Product change notification (PCN)

Title / short description	New UL certificate for the PLC-V8... product range
Affected article category	System cabling for controllers
Change category	Approval
Change number	CCK240006-00
Reason for PCN/PDN Revision

CCK240006

Bedruckungsänderung / *Printing change*

Produktbeispiel / *Product example:* 2295554 - PLC-V8/FLK14/OUT

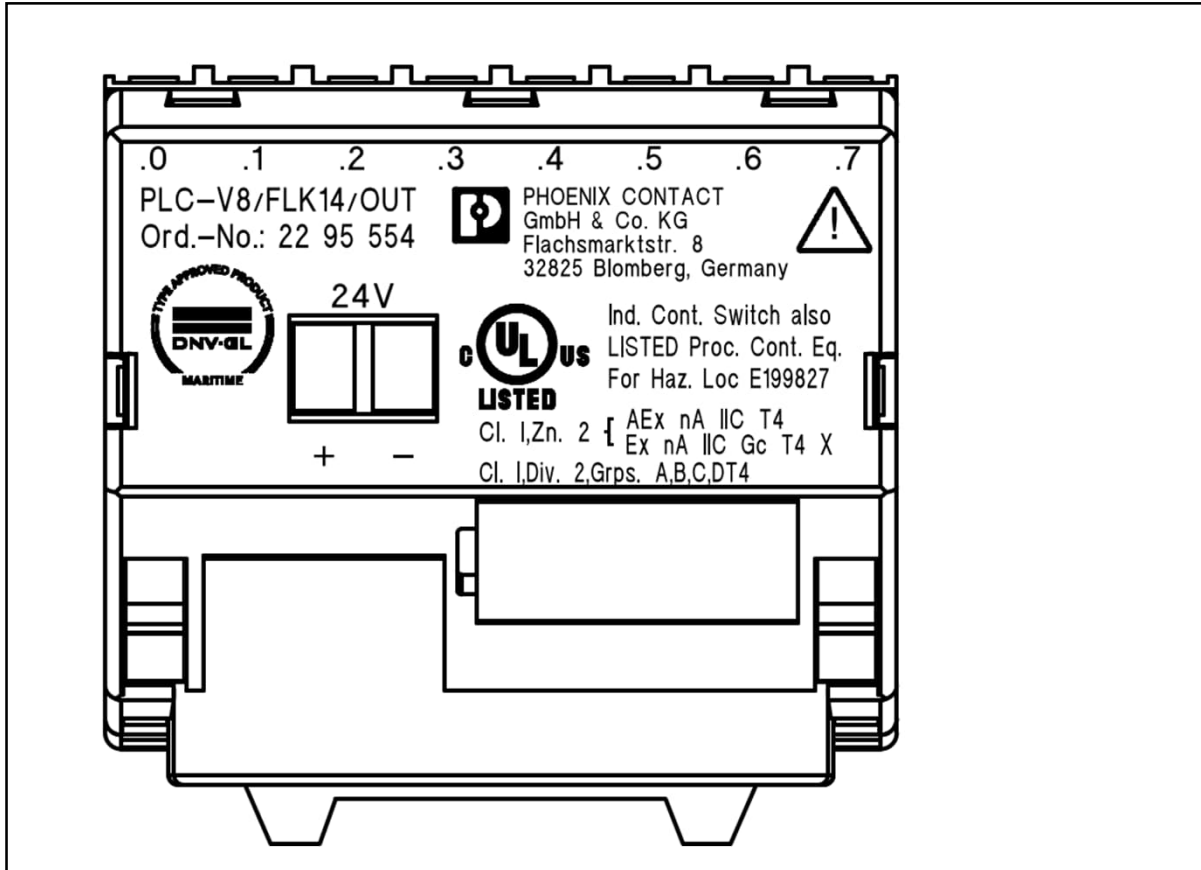
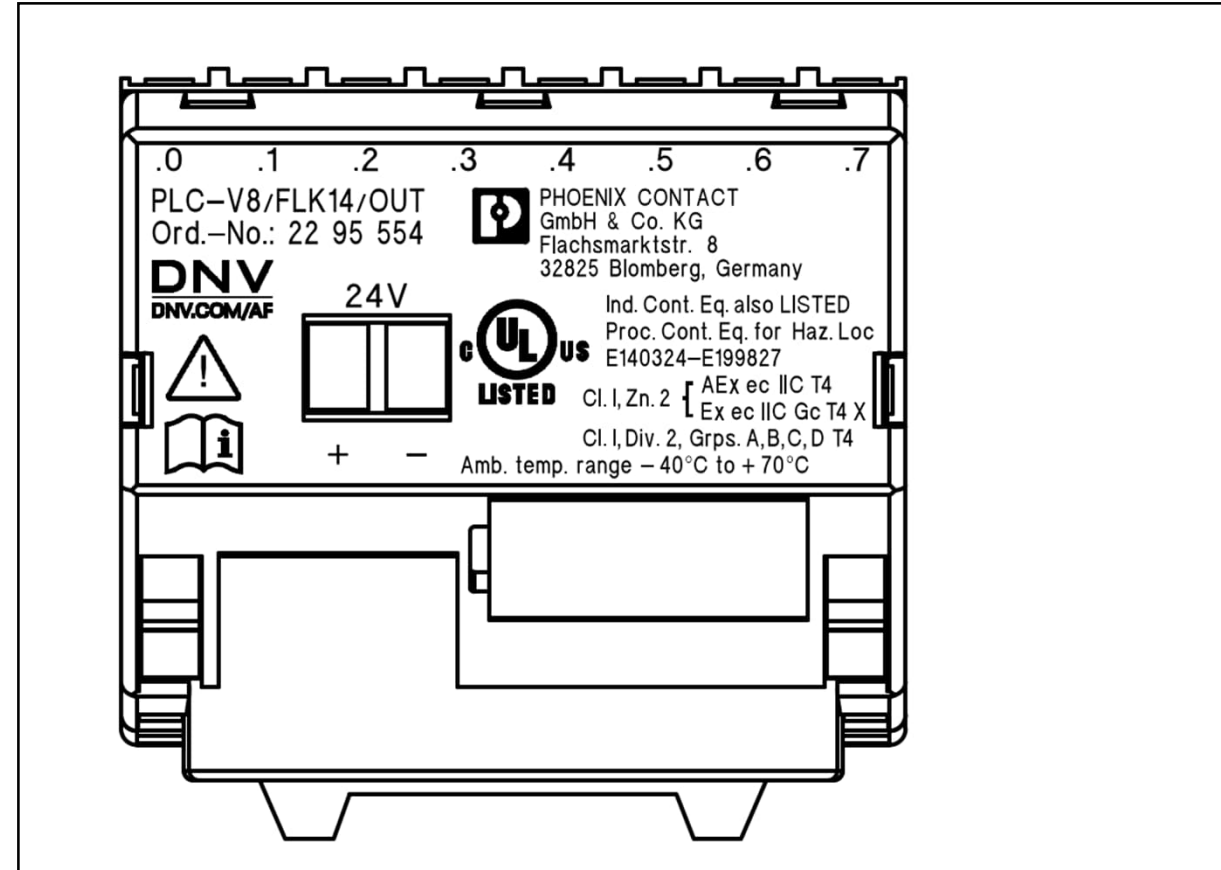
Gilt für folgende Produkte / *Applies to the following products:*

2295554	PLC-V8/FLK14/OUT
2296553	PLC-V8/FLK14/IN
2304115	PLC-V8/FLK14/IN/M
2304102	PLC-V8/FLK14/OUT/M
2296058	PLC-V8/D15S/OUT
2296061	PLC-V8/D15B/OUT
2296074	PLC-V8/D15S/IN
2296087	PLC-V8/D15B/IN

Bisheriger Fertigungsstand / *Current production state*

Neuer Fertigungsstand / *New production state*

Produktbeispiel / *Product example:* 2299660 - PLC-V8L/FLK14/OUT

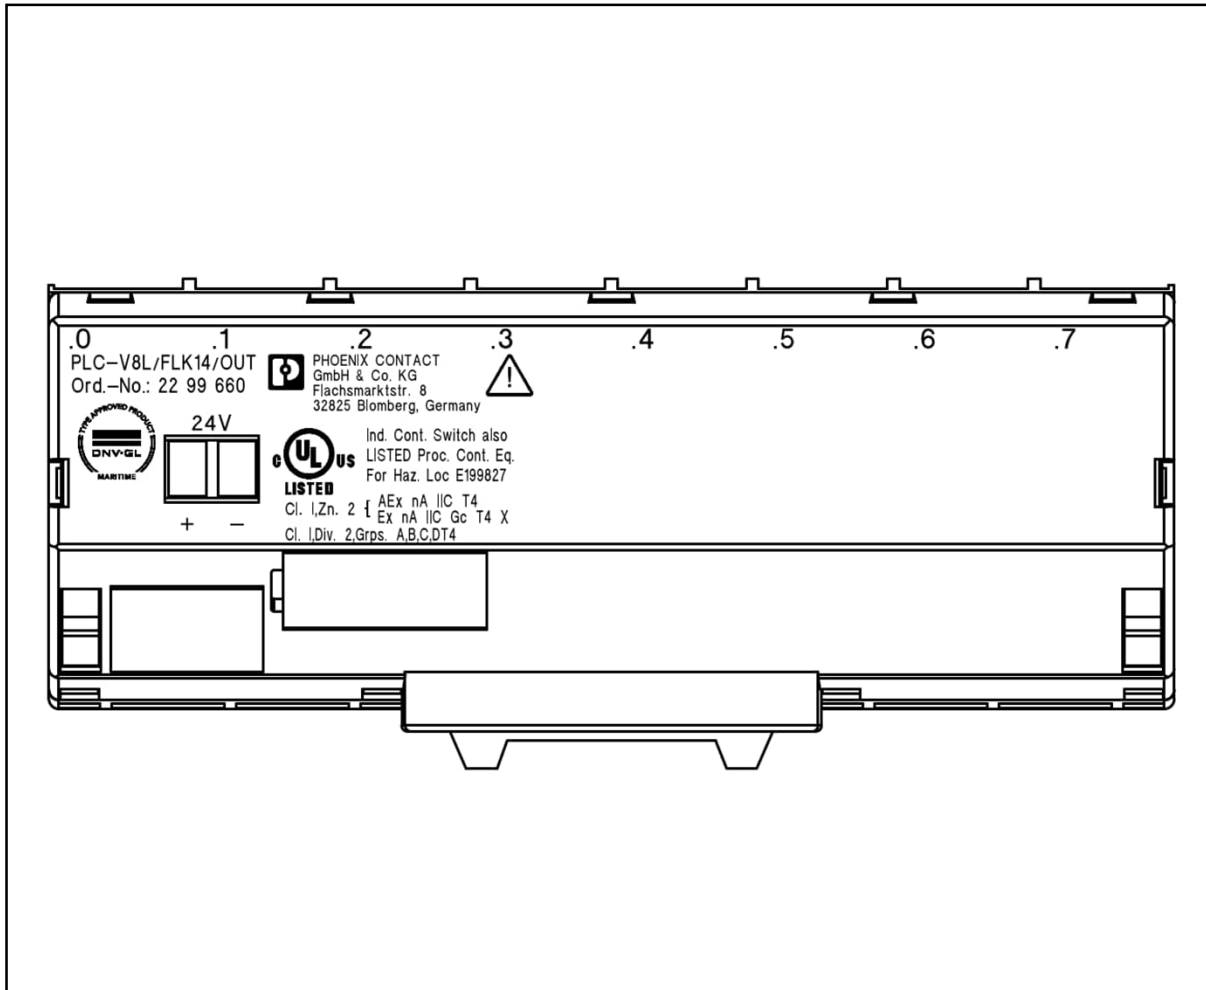
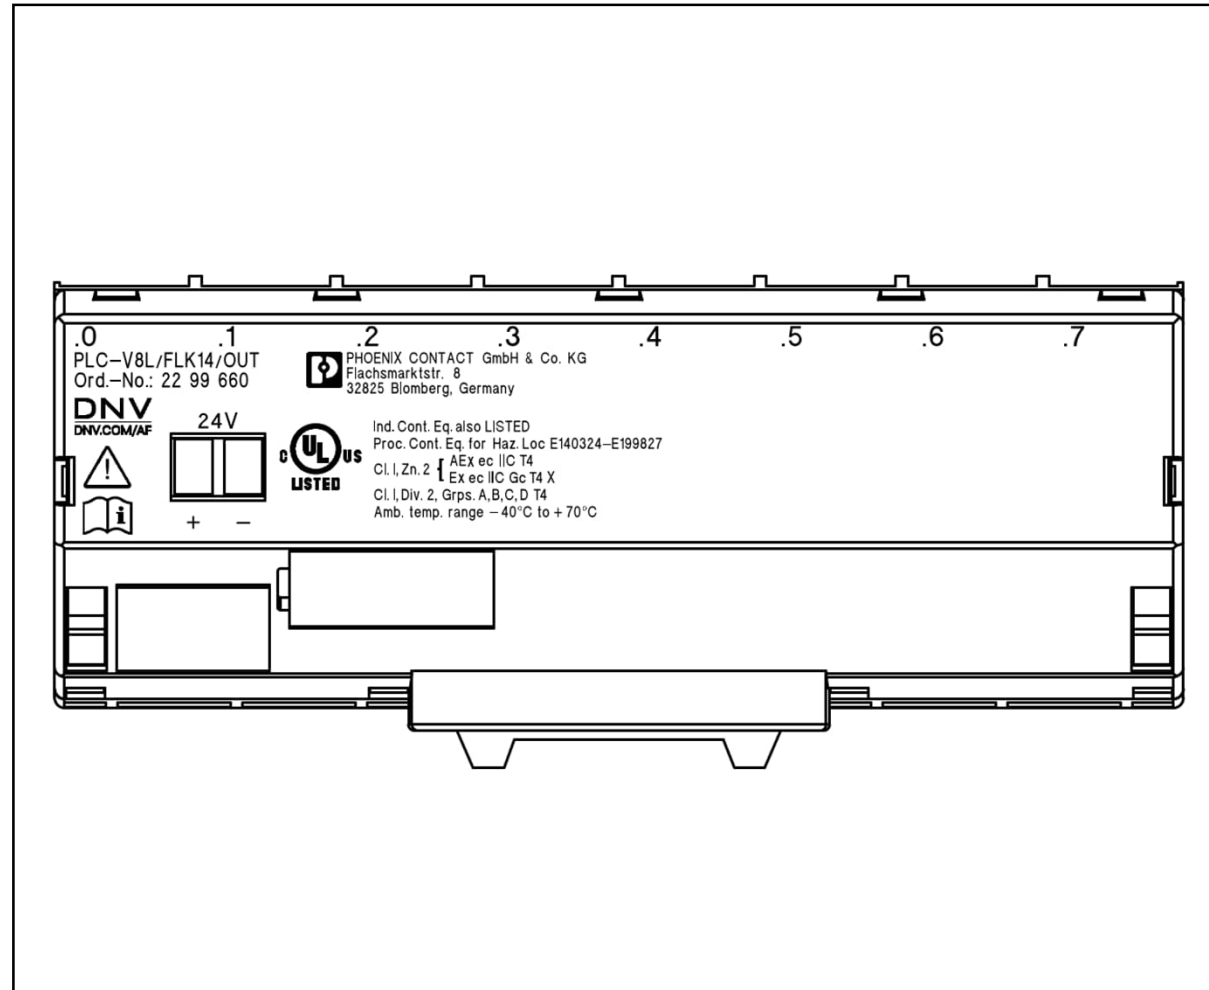
Bedruckungsänderung / *Printing change*

Gilt für folgende Produkte / *Applies to the following products:*

2299660	PLC-V8L/FLK14/OUT
2304306	PLC-V8L/FLK14/OUT/M
1104789	PLC-V8L/D15S/OUT

Bisheriger Fertigungsstand / *Current production state*

Neuer Fertigungsstand / *New production state*

Produktbeispiel / Product example: 2907445 - PLC-V8C/SC-24DC/SAM2

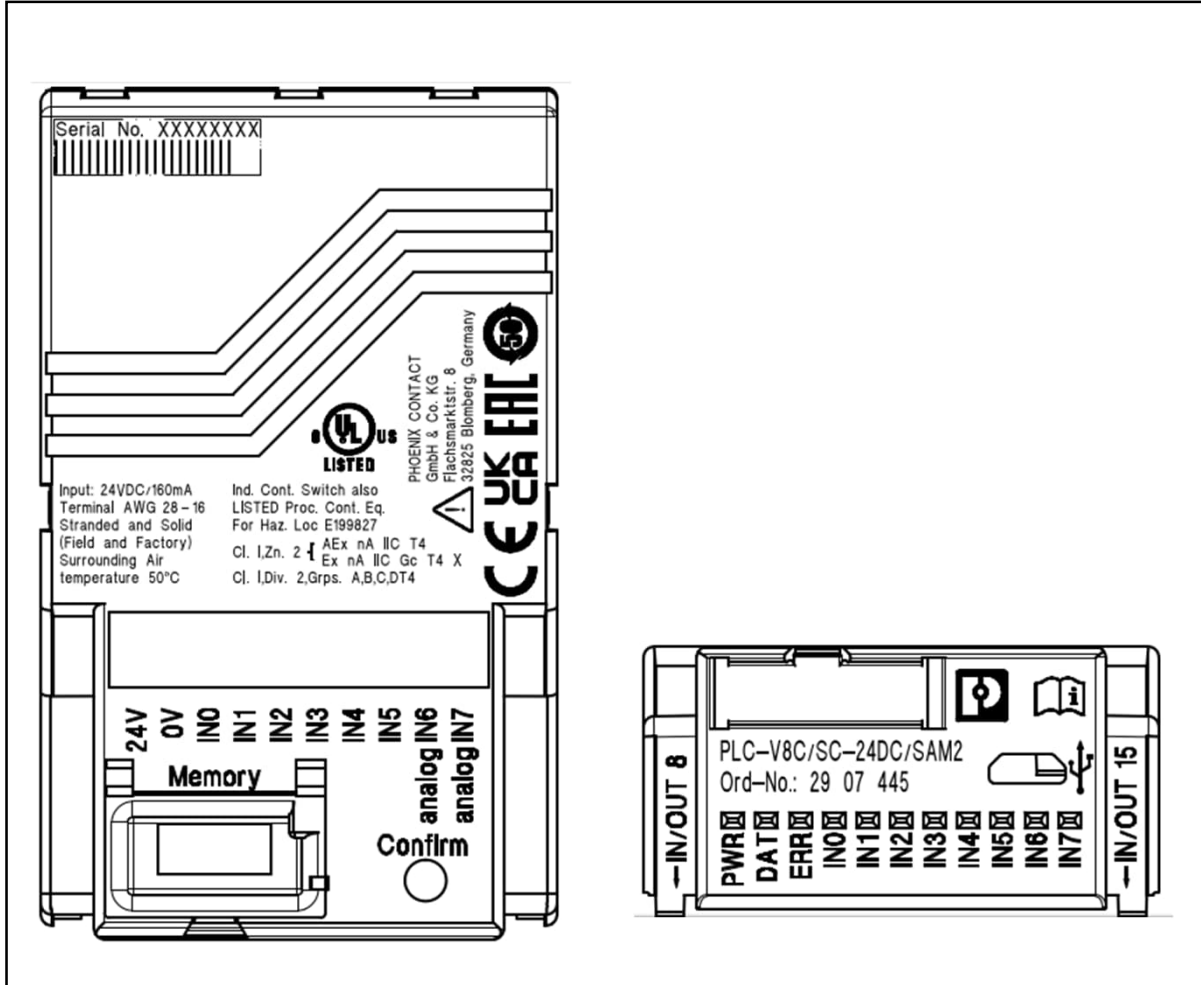
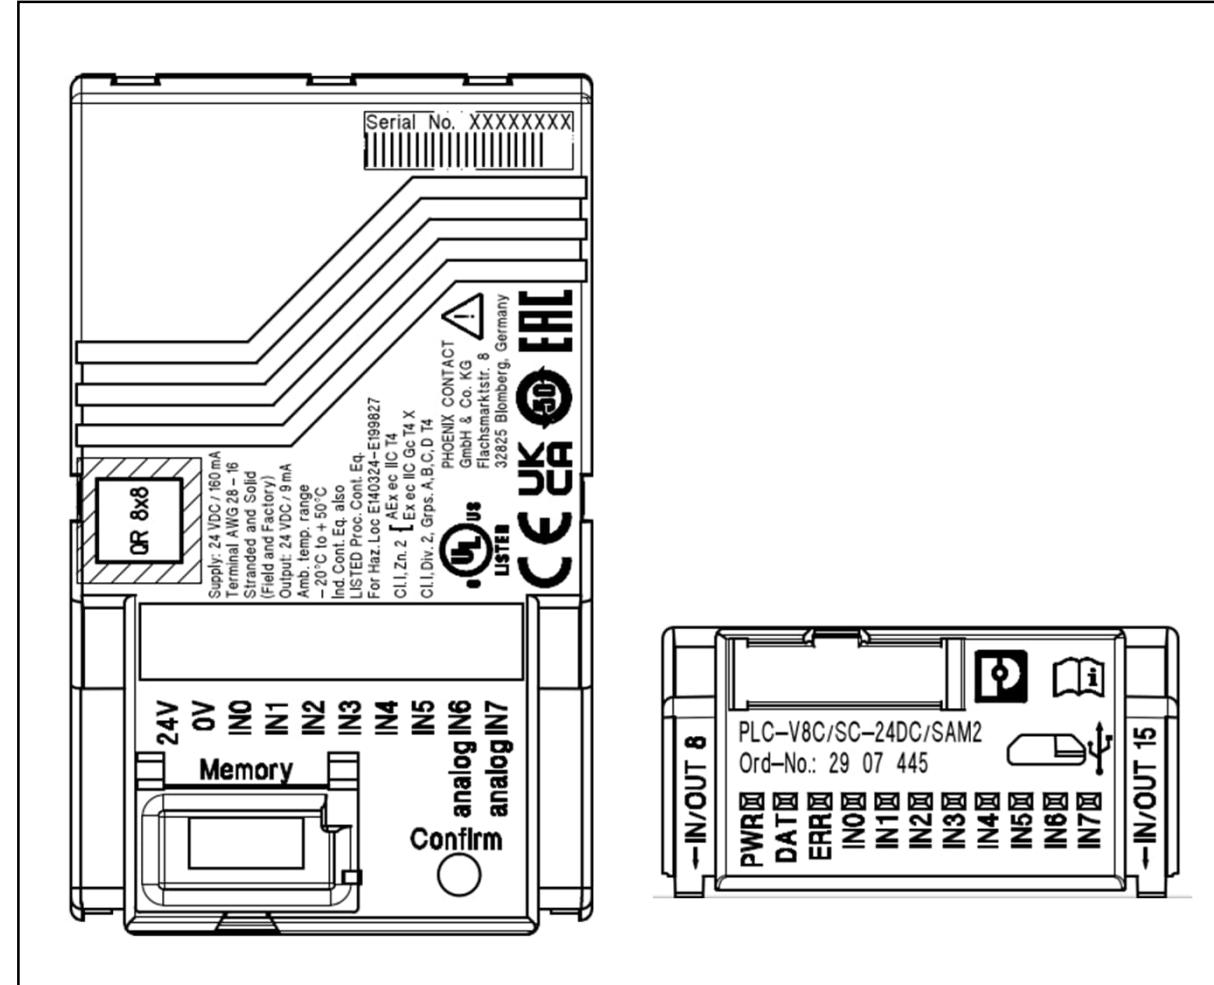
Bedruckungsänderung / Printing change

Gilt für folgende Produkte / Applies to the following products:

2907445	PLC-V8C/SC-24DC/SAM2
2907443	PLC-V8C/PT-24DC/SAM2
2907446	PLC-V8C/PT-24DC/BM2
2907447	PLC-V8C/SC-24DC/BM2
2903095	PLC-V8C/SC-24DC/EM
2905137	PLC-V8C/PT-24DC/EM
1452919	PLC-V8C/PT-24DC/RS485

Bisheriger Fertigungsstand / Current production state

Neuer Fertigungsstand / New production state
